**STAFF REPORT
KETCHUM PLANNING AND ZONING COMMISSION
MEETING OF JUNE 17, 2026**

PROJECT: 330 Topaz Street Residence

FILE NUMBERS: 26-KET-00126 & 26-KET-00135

APPLICATION TYPES: Mountain Overlay Design Review & Lot Consolidation Preliminary Plat

A110
 FIRST LEVEL
 FLOOR PLAN
 1/4" = 1'-0"

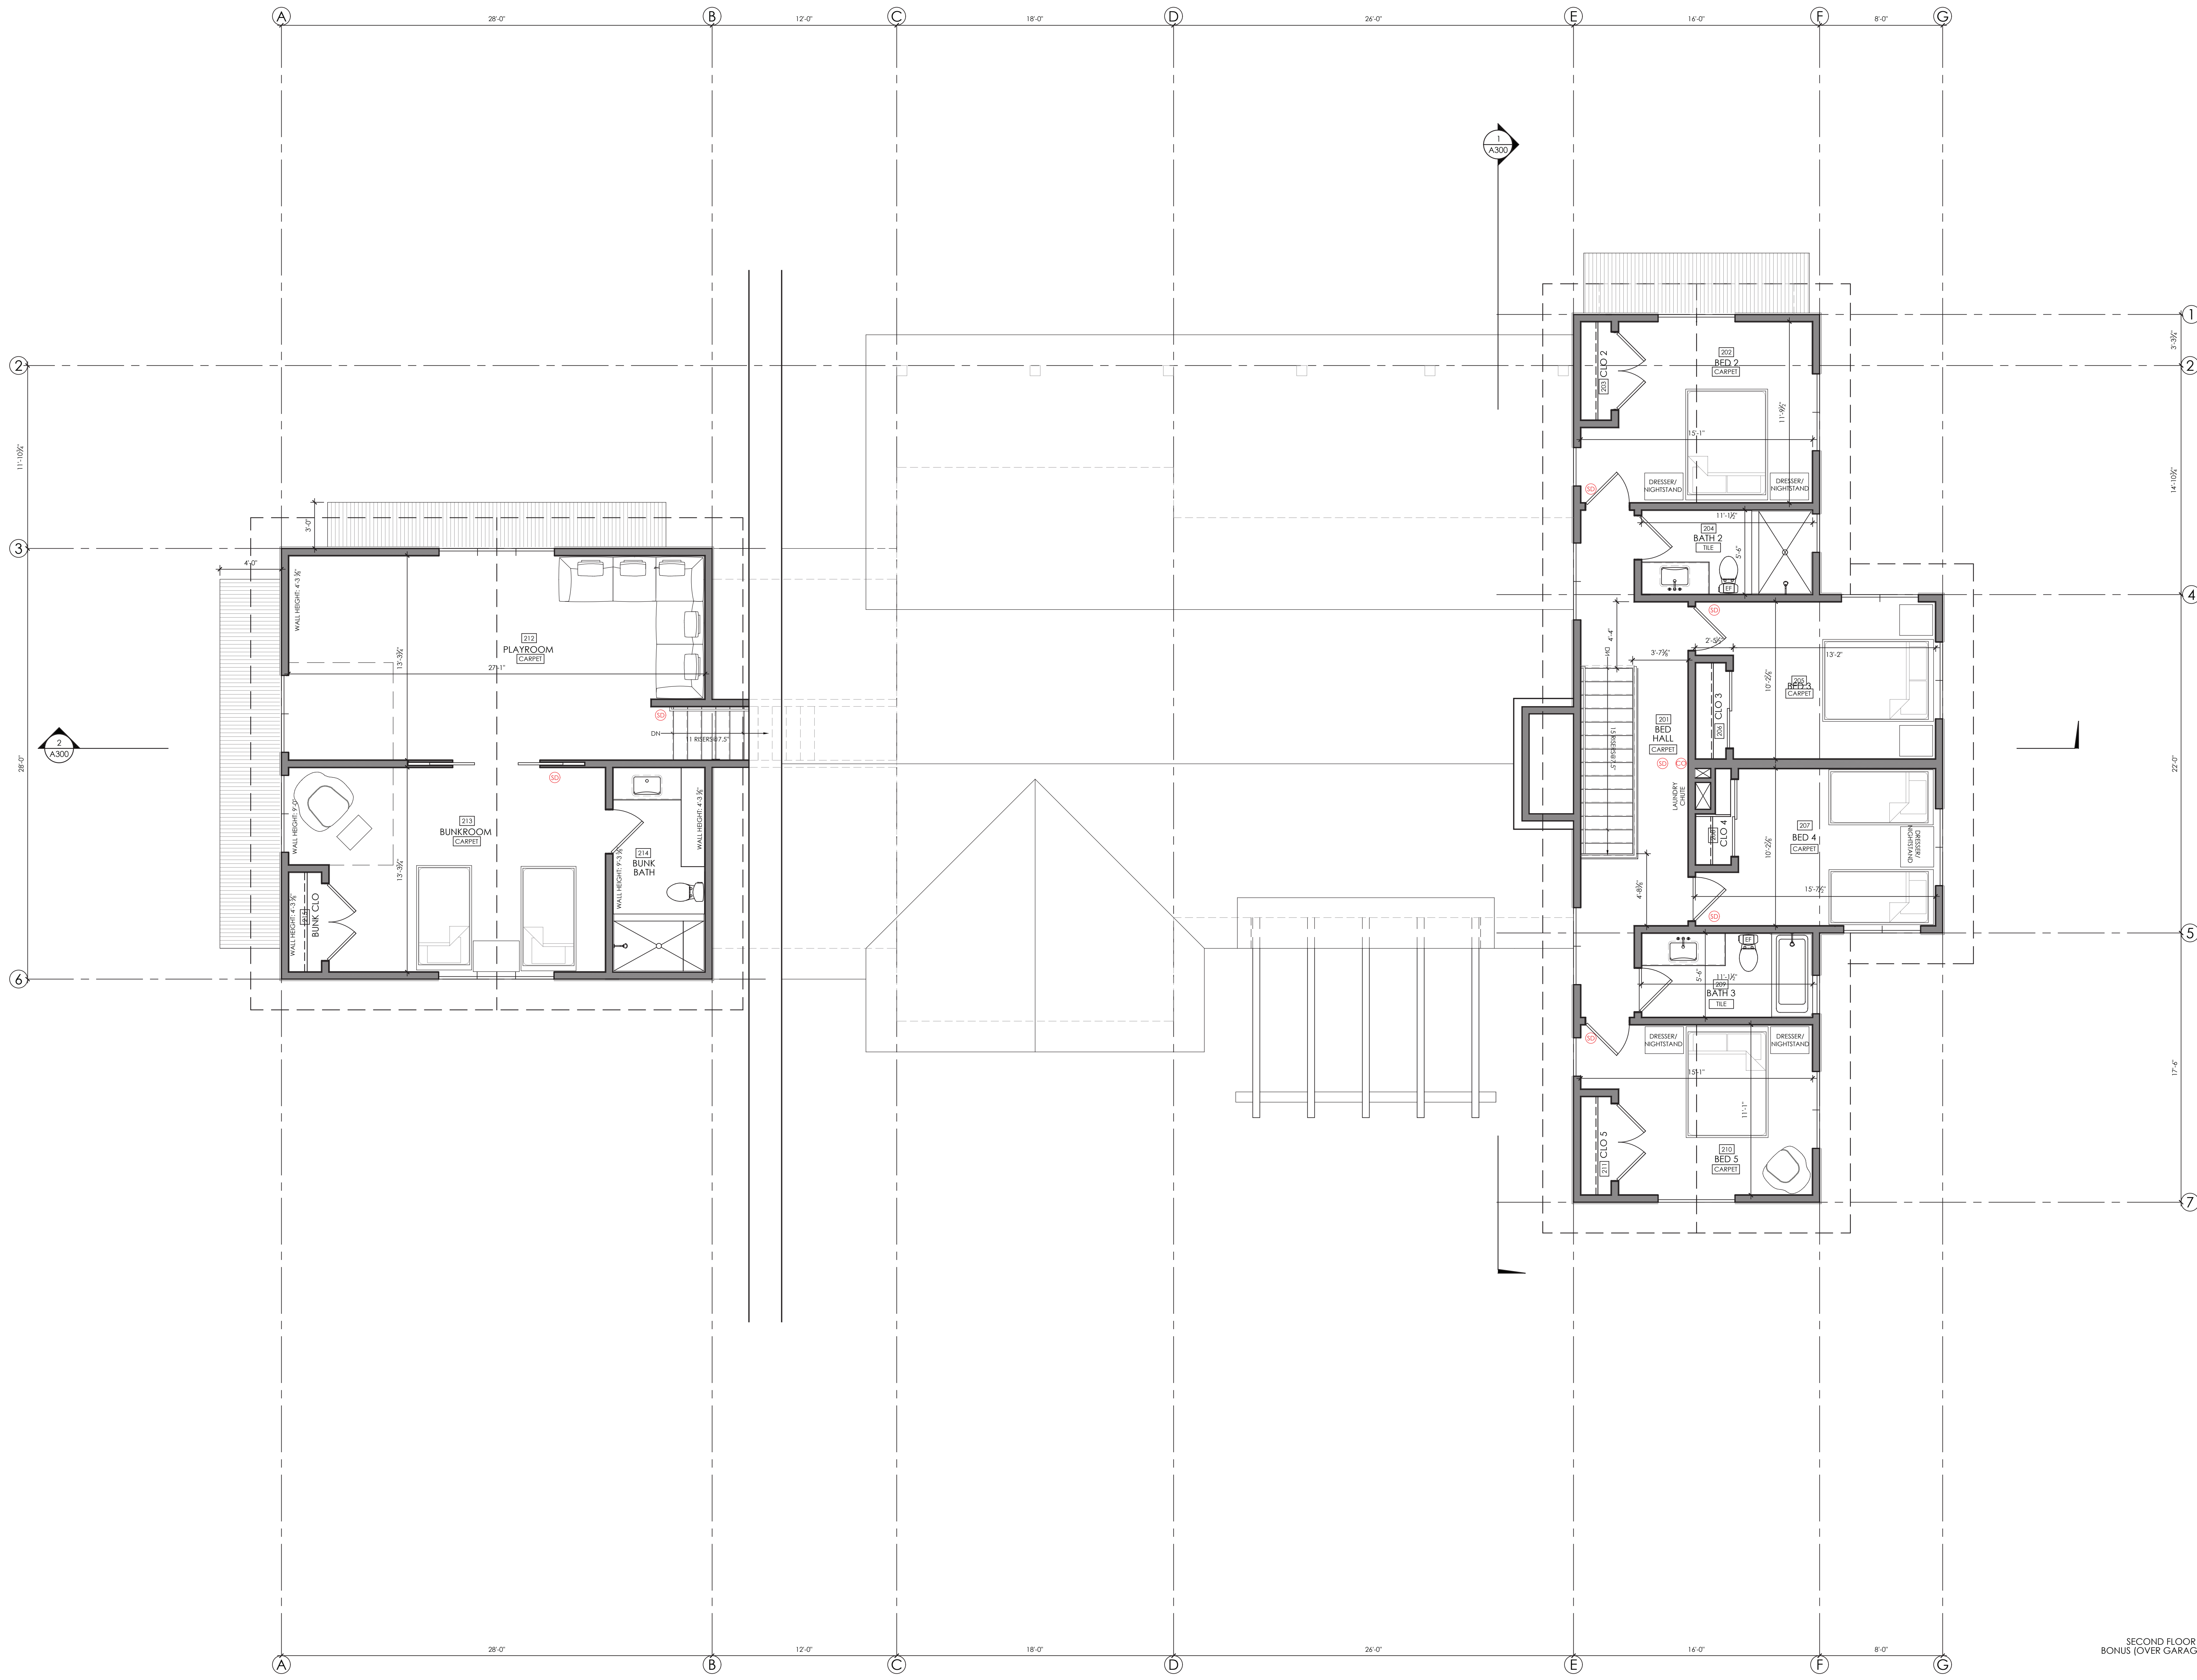
2. **Comment:** KMC §16.04.080.C.5.g requires that garbage storage areas be screen view. While staff assumes the garbage bins will be stored in the garage, the garbage area was not identified on the project plans submitted with the Preapplication.

A110 showing first floor plan with trash bin in the relocated garage.

Preliminary Plat

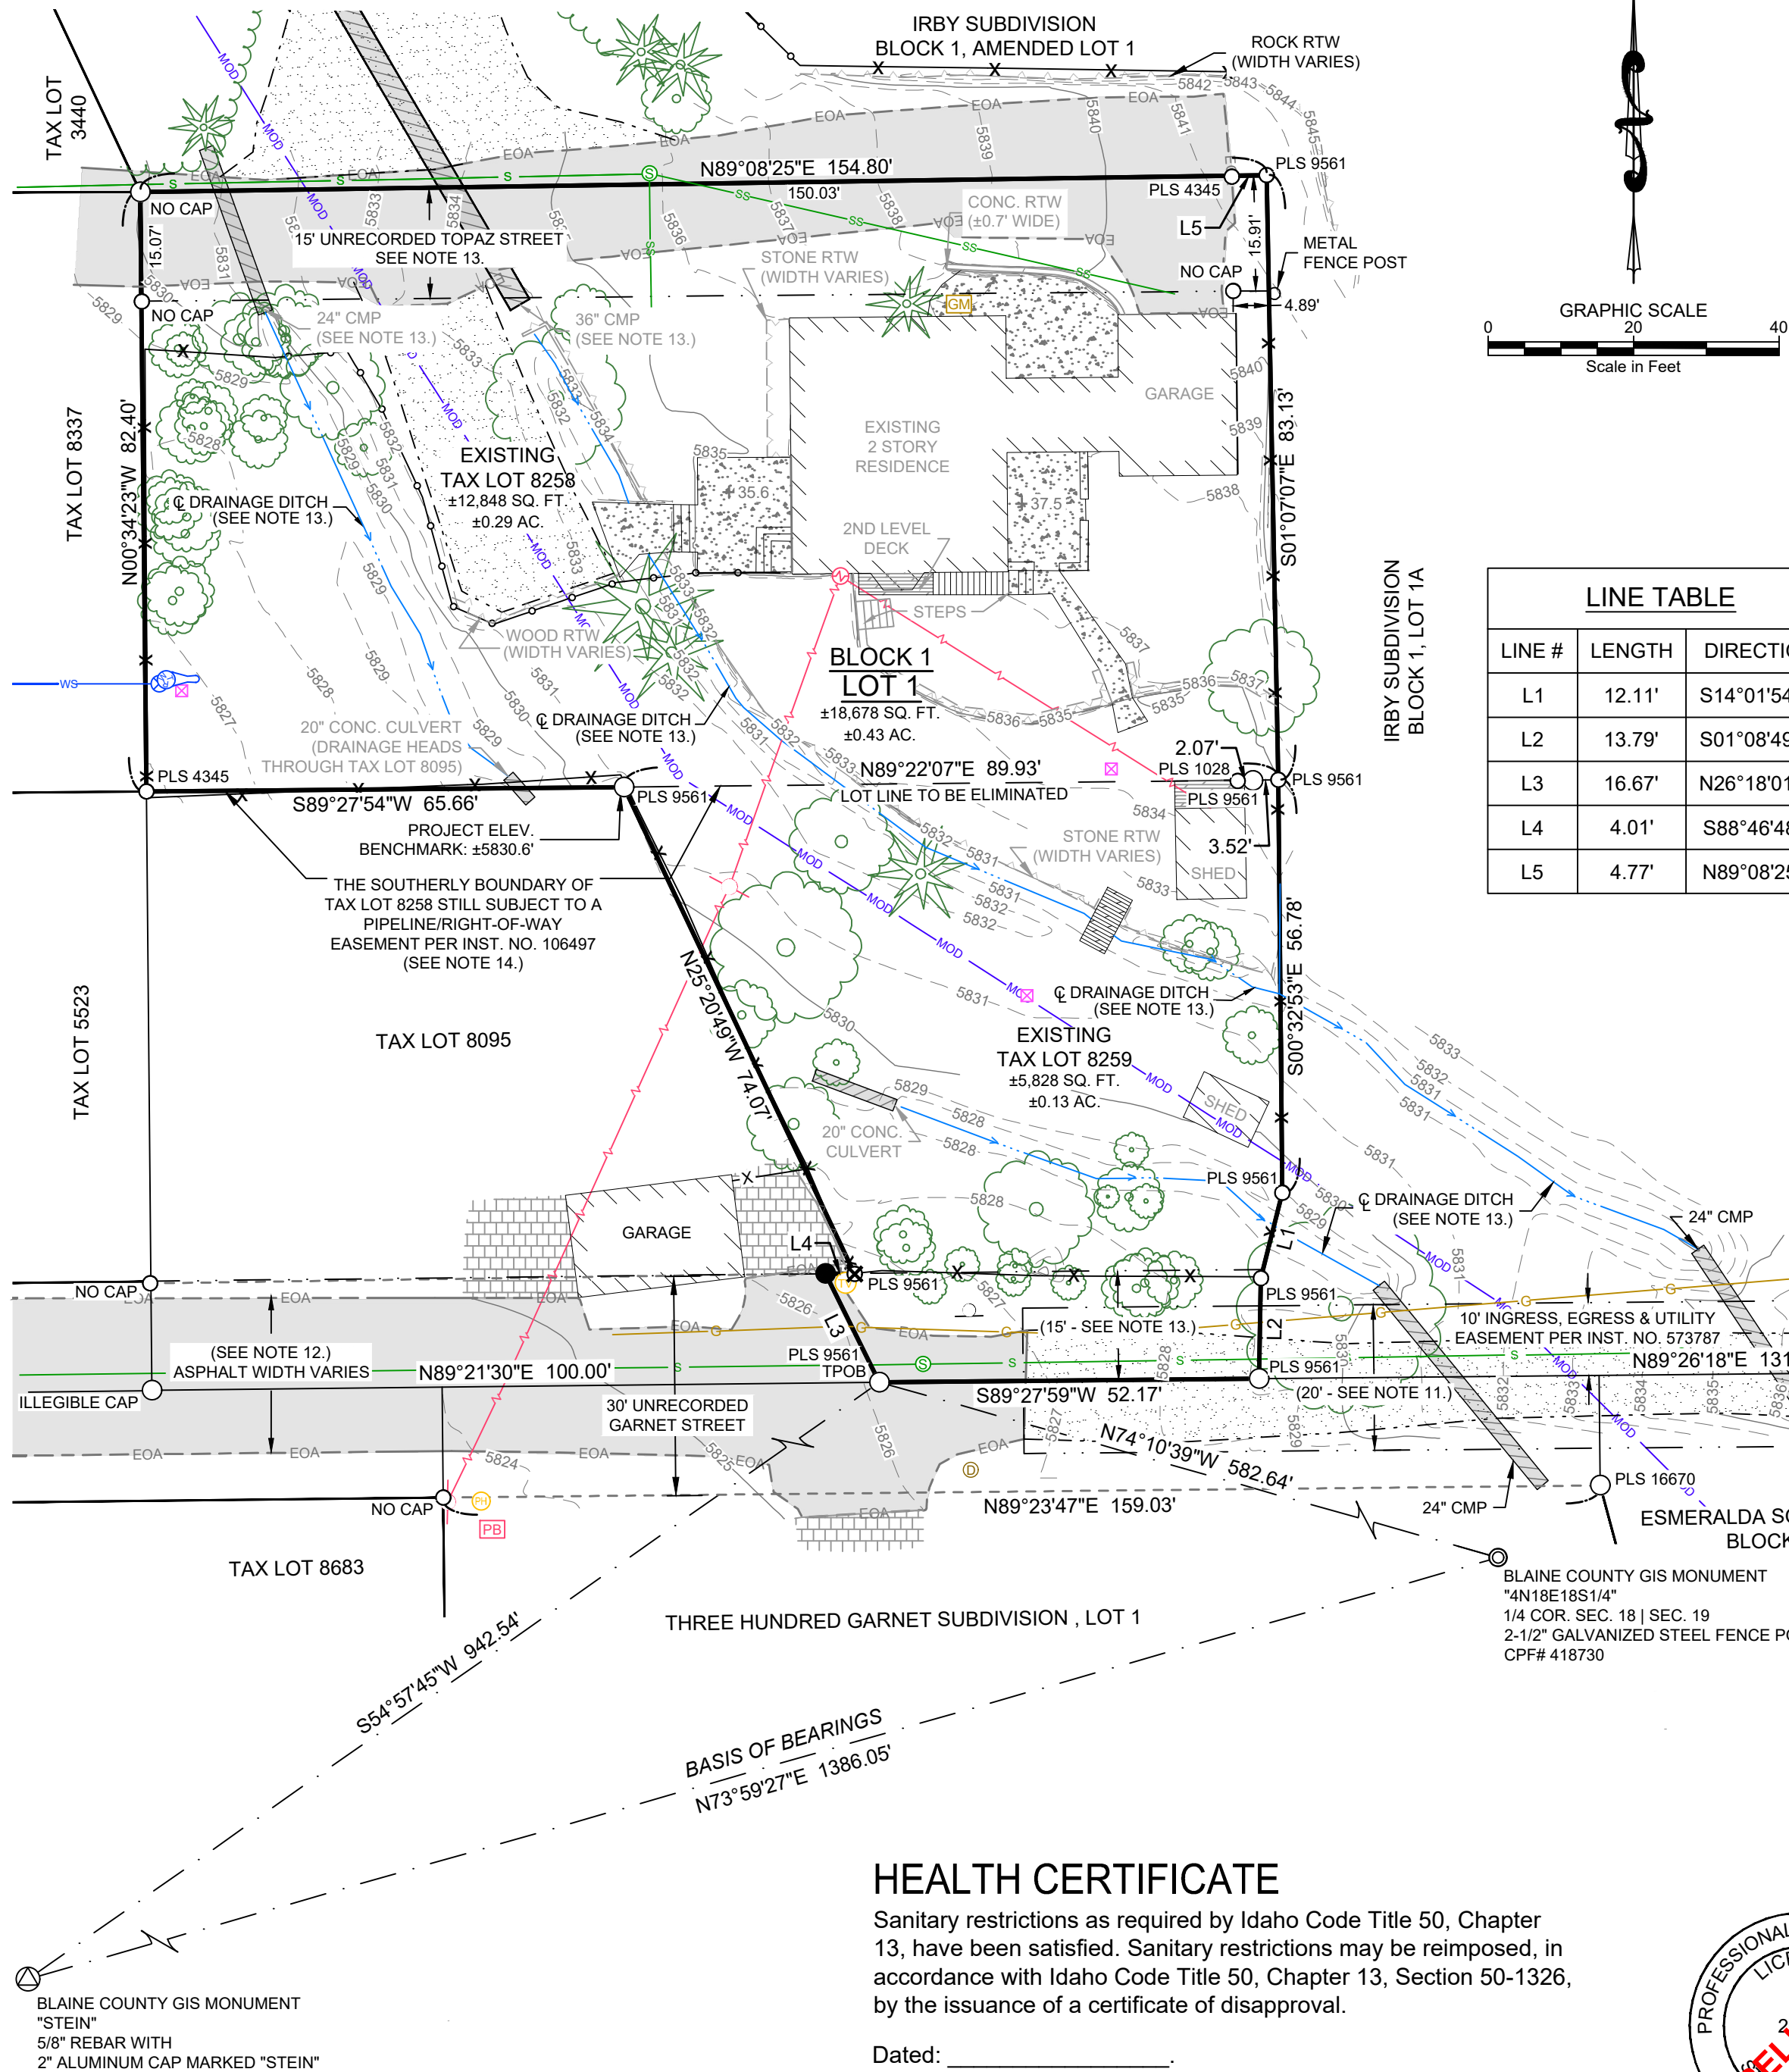
The submitted Preliminary Plat does not currently depict all easements necessary to serve the development. Specifically, the plat does not clearly identify and dimension the proposed turnaround easement area associated with emergency access, fire apparatus operations, snowplow operations, and roadway maintenance at the terminus of Topaz Street. The turnaround configuration is shown in the project plans, including the hammerhead turnaround depicted on Sheet L110, associated landscape improvements shown on Sheet L120, grass-pave treatment shown on Sheet L122, and supporting civil engineering drawings; however, the easement area itself must also be reflected on the Preliminary Plat.

In addition, the property contains two irrigation conveyances, commonly referred to as the McCoy (Weyyakin) Ditch and the Reinheimer Ditch. The applicant proposes to relocate portions of these conveyances into underground piping to accommodate the proposed residence and associated site improvements. While the final alignment and design remain subject to additional review and approval by the City, the Final Plat must ultimately identify and provide easements sufficient to contain the relocated conveyances and provide for ongoing maintenance, repair, replacement, and reconstruction access. Easement locations associated with the relocated conveyances may therefore be refined during final engineering review and reflected on the Final Plat.

Accordingly, staff recommends that the Preliminary Plat be revised prior to City Council consideration to clearly depict, dimension, and dedicate the fire apparatus, emergency services, and Streets Department turnaround easement area. In addition, the Final Plat shall be revised, as necessary, to reflect the final approved location and dimensions of easements associated with the relocated McCoy and Reinheimer irrigation conveyances.

2. Prior to City Council consideration of the Preliminary Plat, the applicant shall revise the Preliminary Plat to clearly depict, dimension, label, and dedicate all easements required pursuant to LDC §16.07.080.A.1.c(2)(A)j, including the fire apparatus turnaround easement, emergency services turnaround easement, and City Streets Department turnaround easement associated with the hammerhead turnaround at the terminus of Topaz Street. The location and dimensions of the easement shall be subject to review and approval by the Fire Department, Streets Department, City Engineer, and Planning Department.

4. Prior to recordation of the Final Plat, the applicant shall revise the plat as necessary to depict the final approved location, dimensions, and maintenance easements associated with the relocated McCoy (Weyyakin) and Reinheimer irrigation conveyances. Easement widths shall be sufficient to contain the conveyance facilities and provide access for maintenance, repair, replacement, and reconstruction in accordance with LDC §16.06.050.F.2.
